SUBMITTED FOR APPROVAL
By: R. R. Barnes
DATE: 4/19/93
R. R. Barnes
Shambaugh & Son Fire Protection

CAD DWG 231292-1
SHEET NO. 231292
PP-1 OF 2

PROJECT NAME:
VISION MOLDED PLASTICS, INC.
1675 INDUSTRIAL DRIVE
NAPOLEON, OHIO

SITE PLAN
SCALE 1"=40'

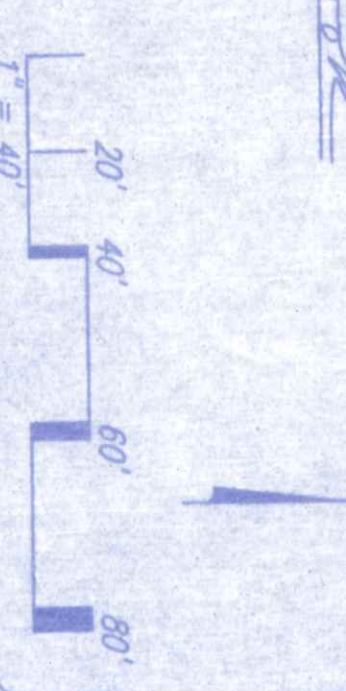
We have provision to believe that this area is increased in steel, which would not allow a tap as proposed. Also we do not have easement in part of the area proposed to be crossed over.

what type of pipe is this? If PVC is used there must be a 12 gauge stranded copper wire along the entire length of line.

This tank is not in this location.

connecting to object. Sec. 1019.5. Location of fire department. Connection shall be located front of street front of building.

MR. Right of Way. Please provide road crossing detail. We will require a permit to install as shown.
